Gunnedah Solar Farm

SSD 8658

Response to Submissions

Figure 1-2 Updated Constraints Map

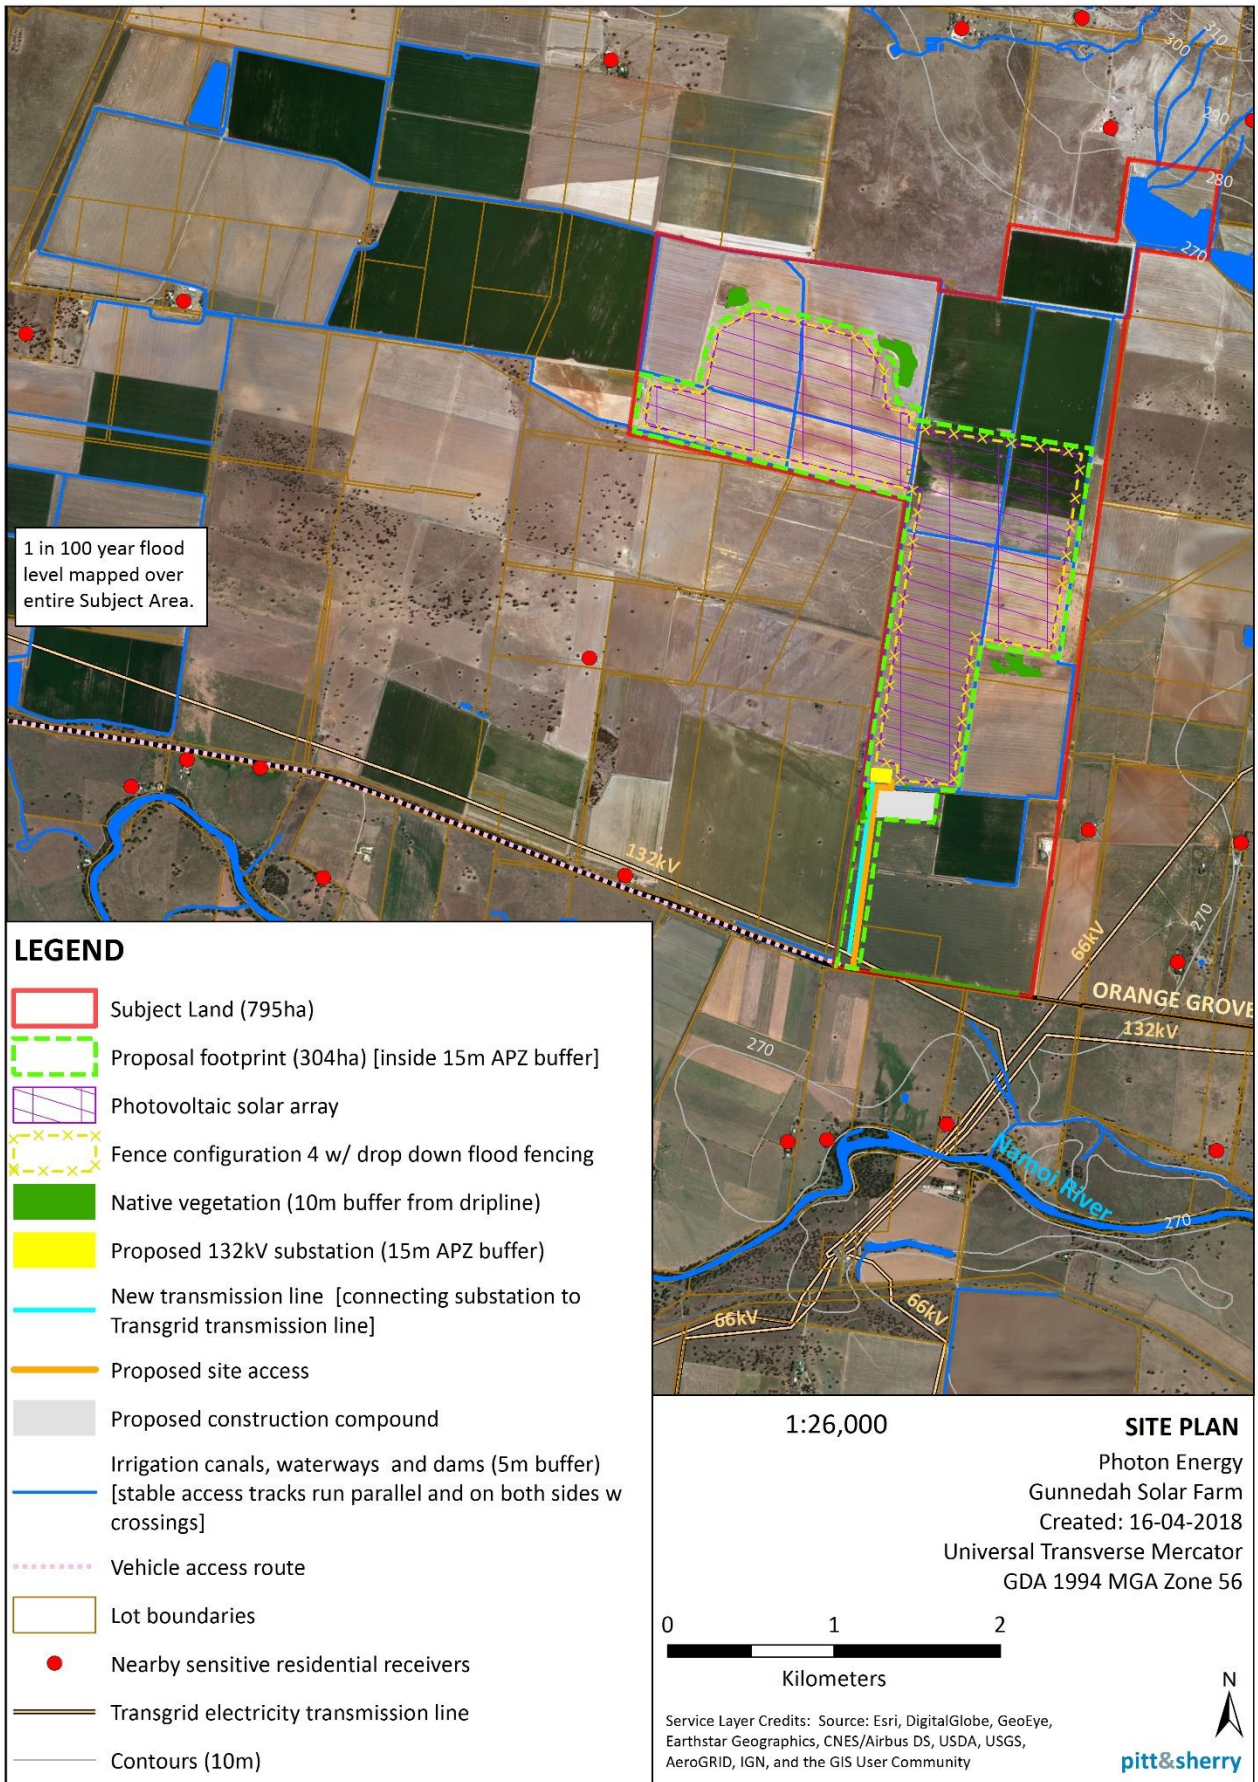
The locality of the GSF is shown in Figure 1-1. An updated site constraints map, as requested by Gunnedah Shire Council is shown in Figure 1-2.

Figure 3-1 Proposed fence design as Fence Configuration 4

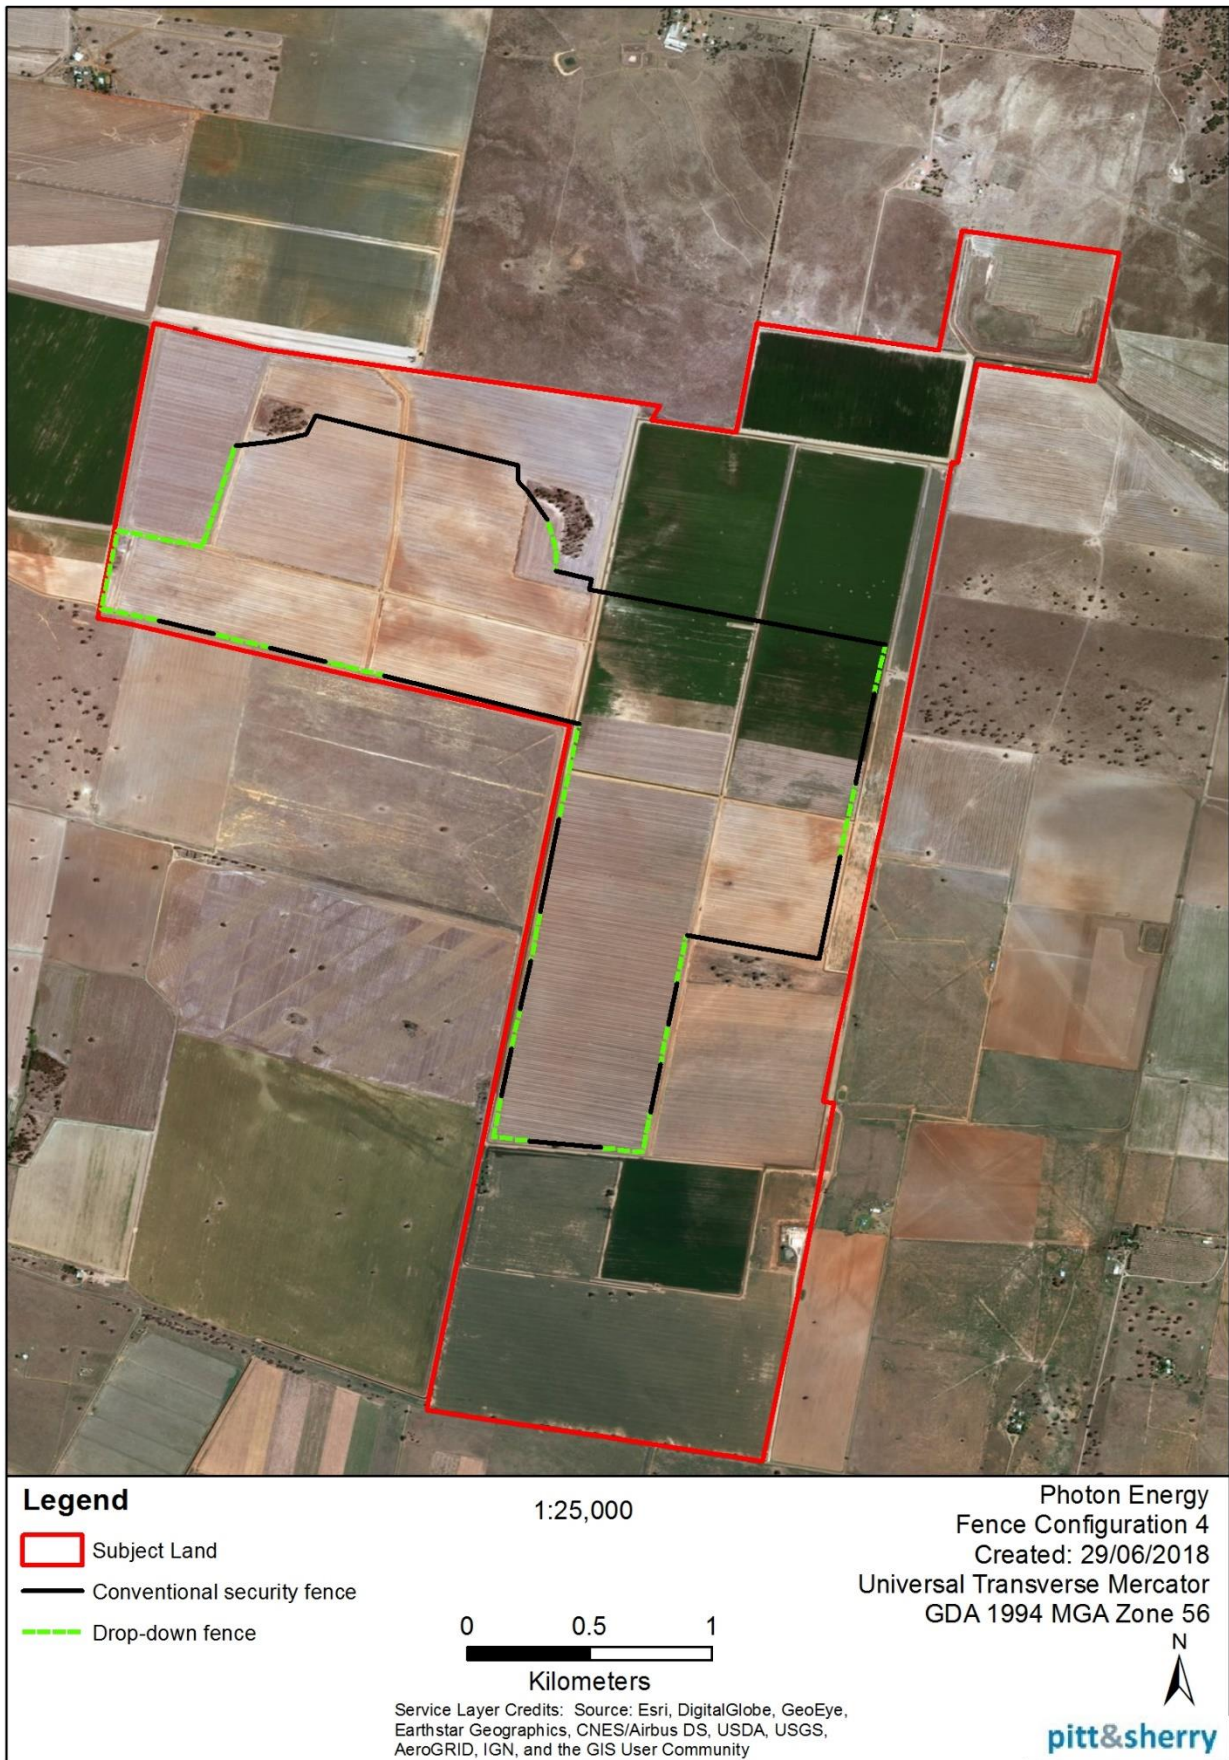
A new fence configuration (referred to as Fence Configuration 4) has been developed and modelled as depicted in Figure 3-1, and further described in Appendix C. It represents an alternative fencing design aimed at minimising blockage and redirection of floodwater and the potential impacts of the Proposal on the surrounding landscape and residents during a flood event. Fence Configuration 4 incorporates drop down fencing in key areas. The model indicates that Fence Configuration 4 further reduces flooding impacts compared to the preferred fence configuration presented in Appendix J of the EIS (Configuration 3) and produces an entirely acceptable outcome that is compliant with the Carroll-Boggabri Flood Management Plan 2006 and have negligible flood impacts on surrounding properties.

GSF commits to construction of perimeter security fencing which is designed to allow flood water into and through the development site during significant flood events to minimise potential redirection of flood flows due to fence blockage. Design of the fencing shall seek to prevent offsite impacts in relation to flood levels and flood velocity, consistent with the complying works criteria in the Carroll to Boggabri Floodplain Management Plan 2006. The detailed design of the perimeter security fencing would be undertaken post consent and as part of construction certificate approval.

Figure 22: Fence Configuration 4 layout (red lines are the drop down fences modelled as fence openings)

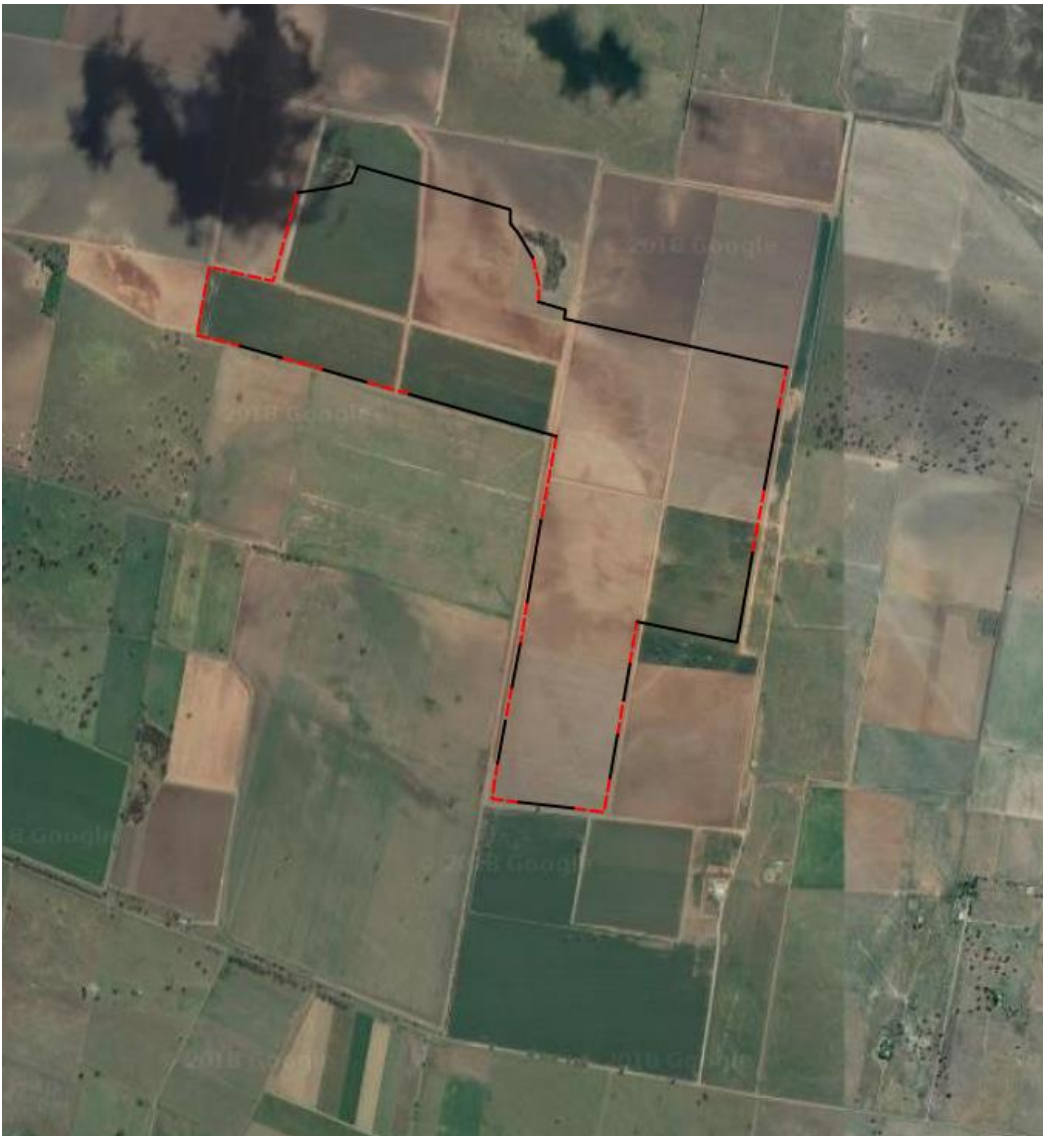
Figure 22 details the location of drop down fencing for Configuration 4. This layout was selected based on the flood model results with drop-down fencing applied in areas of greatest flood flows and generally where fences are aligned perpendicular to the flood flows. The layout was optimised through various iterations using the flood model. The precise location and details of the drop-down fence would be finalised as part of detailed design. Note that in relation to blockage the modelling assumes:

Configuration 4 represents one possible layout for the drop-down fencing and is modelled within this updated flood assessment to assess its effectiveness as a mitigation option. Should it be considered necessary, further flood modelling can be undertaken once the fence layout is finalised at detailed design stage, post approval.

Figure 2 Revised subdivision plan layout

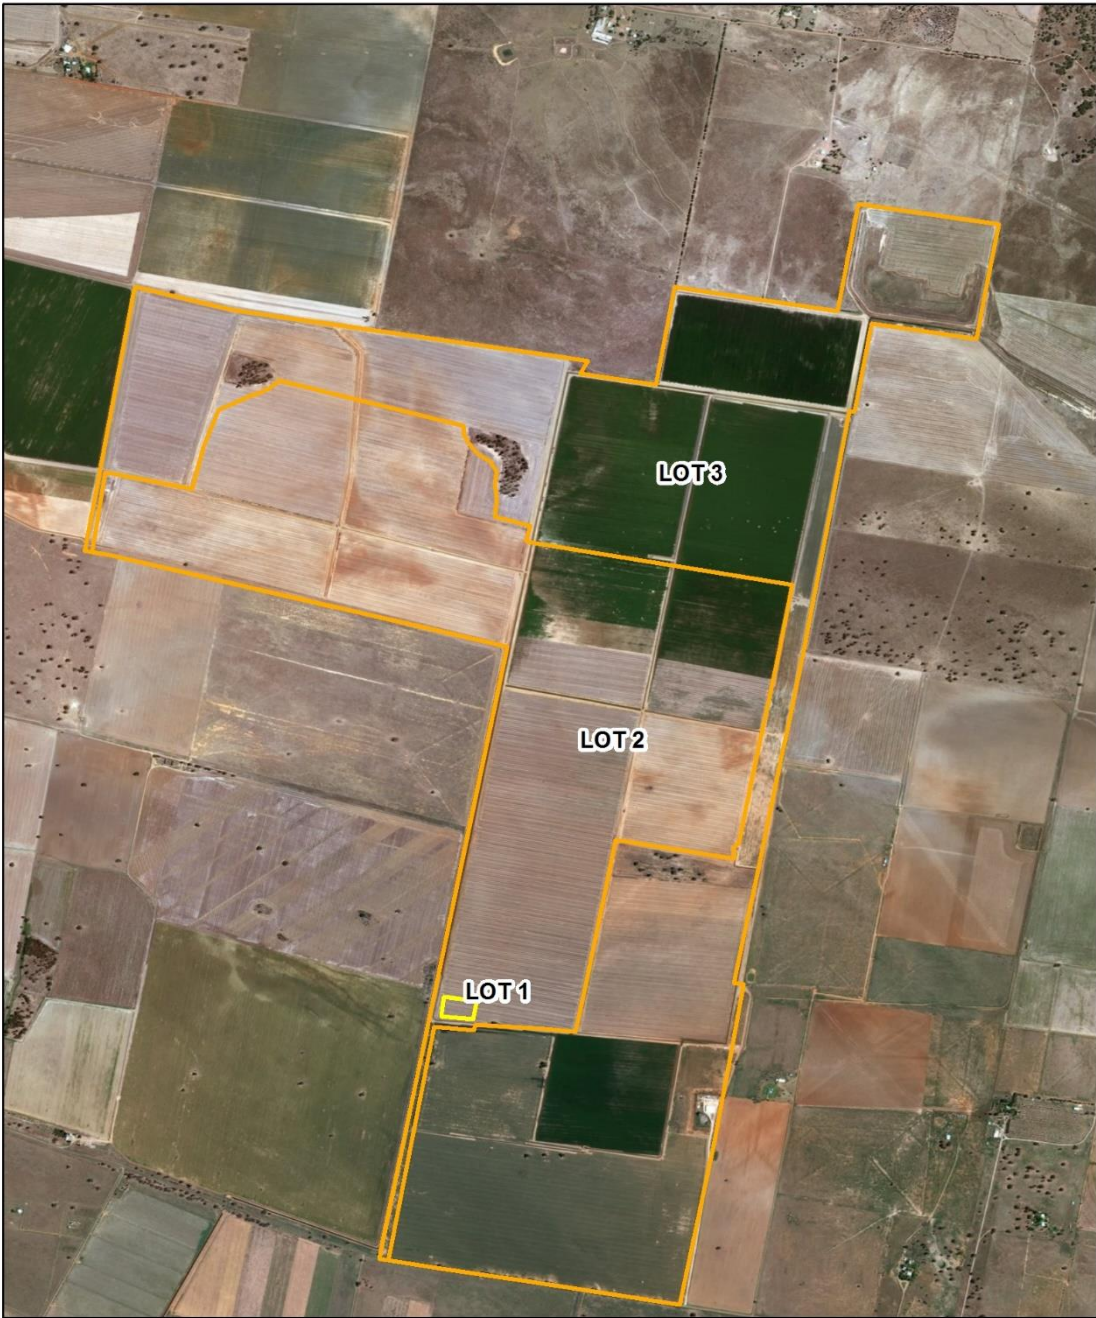
Existing subdivision of land is depicted in Figure 1. This revised subdivision plan identifies an additional subdivision of 4800m² on part of Lot 264 DP754954 containing the TransGrid substation. The need for this additional subdivision is to provide a separate lot to be owned by TransGrid to contain the substation.

The proposed revised subdivision plan layout is provided in Figure 2.
